# Agenda for assembly in cleanroom session

# Fermilab CAF cleanroom Vacuum / Purge / Backfill Manifold

**DESY units (flushing issue)**

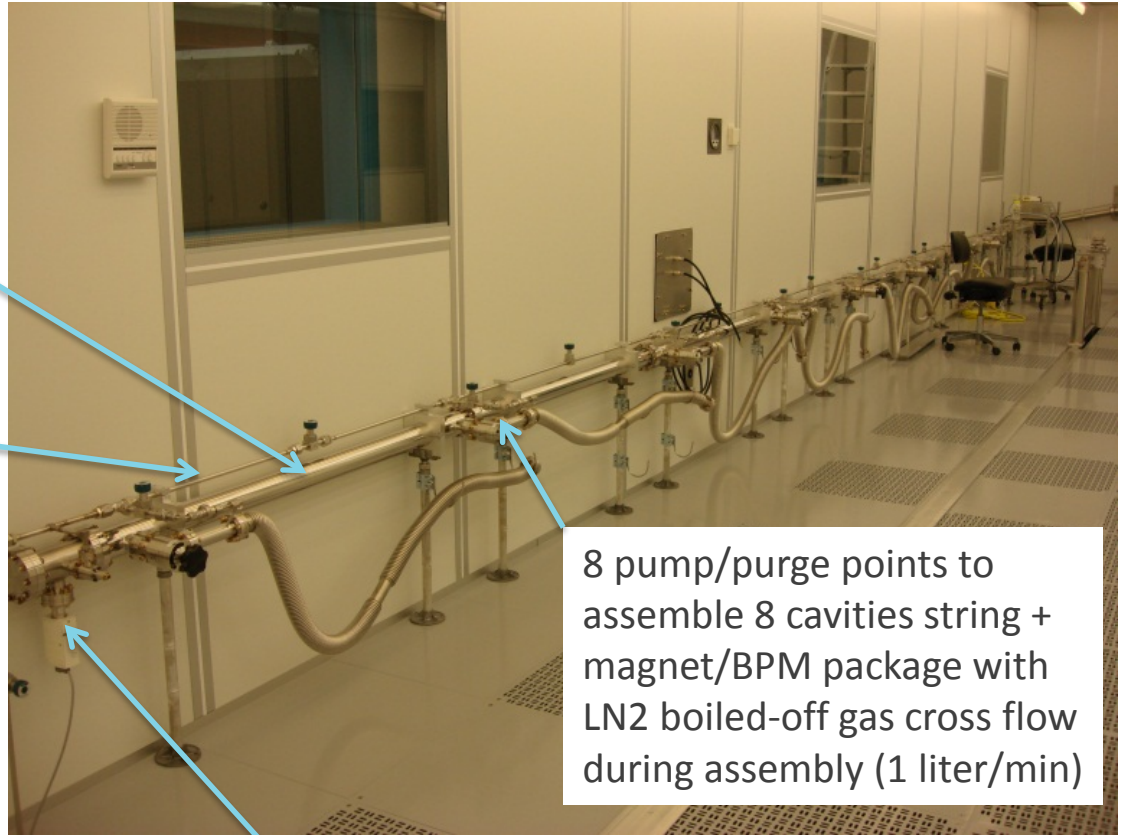
- Cavity and Nitrogen manual valves: identical => pump damaged or process delay... manual => if forgotten cavity back to HPR...
- Do: different type of manual valves for nitrogen line on each pumping unit Aptech springless series AZ30 2 10-10mbar/s
- Check: leak tightness and particulates generation : OK Ceramic Filter Removal Rating > 99.999999 % at 0.003 µm
- Analyse: CCC564 out of XM5 (N<sub>2</sub> forgotten) !!

## String Assembly Differences (cont.)

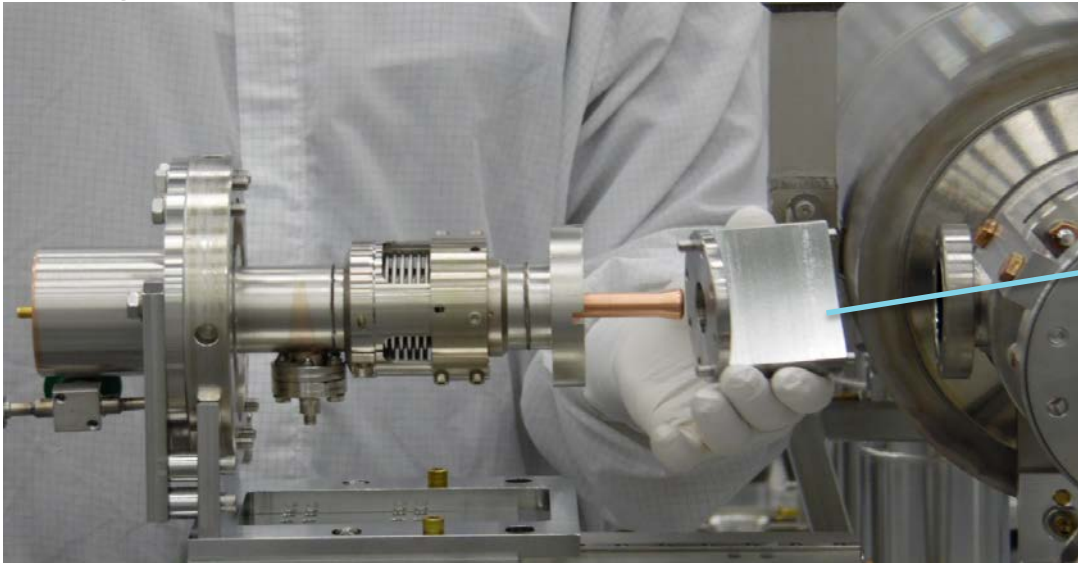
Recommendation noted to clean this tooling after each string assembly

Better process control and quality assurance checks to eliminate the alignment problems encountered during assembly of pCM

# String Assembly Differences (cont.)

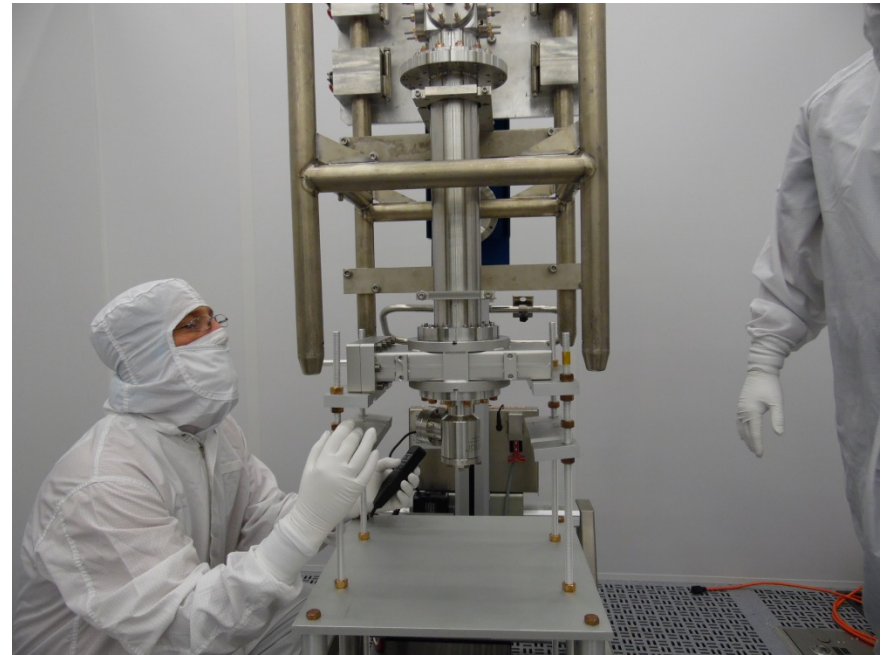
Modified for ProdCM string assembly, it will be done in horizontal configuration

# String Assembly Differences (cont.)

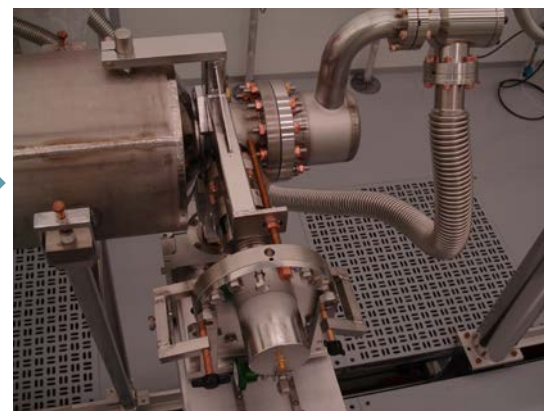
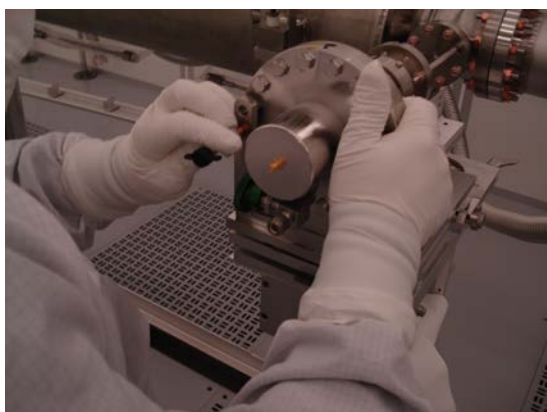
Recommendation noted for use of torque wrenches for LCLS-II strings assembly in the cleanroom

Over-torqueing of the fasteners to fix a leak is noted. DESY recommendation shall be reviewed further

# String Assembly-I (WS1)

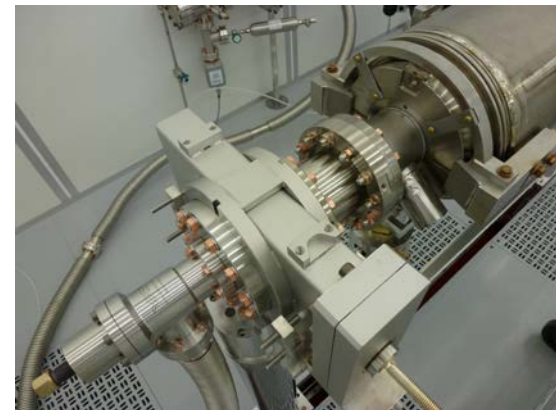
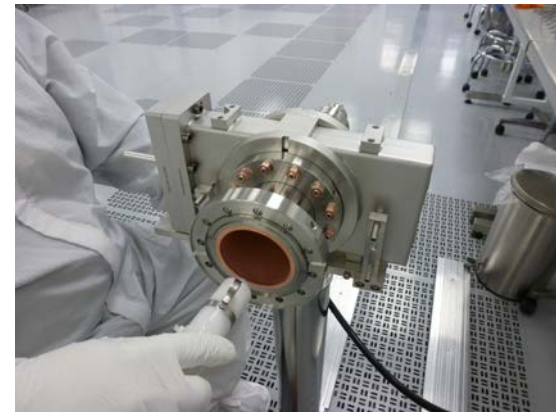
Recommendation noted that gate valve is opened and closed several times at JLab during particle free cleaning with ionized nitrogen

# String Assembly-III (WS1)

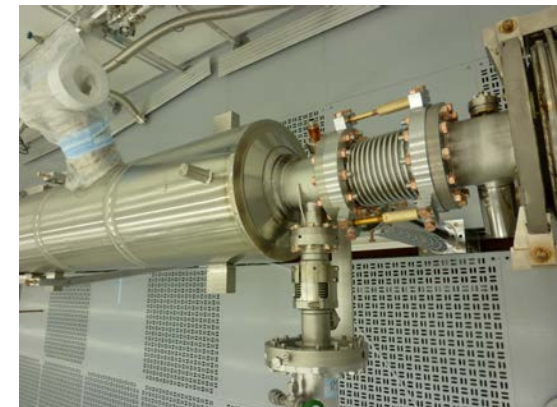
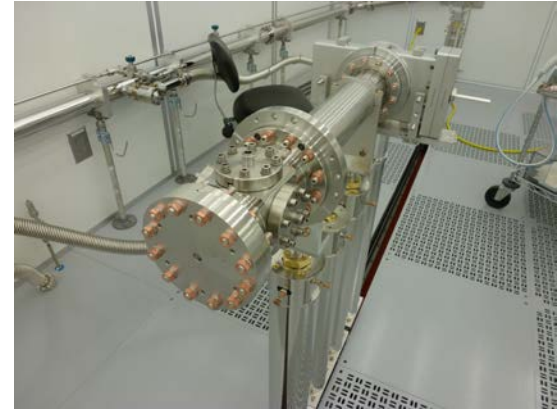
Alignment pins currently are not used at neither labs
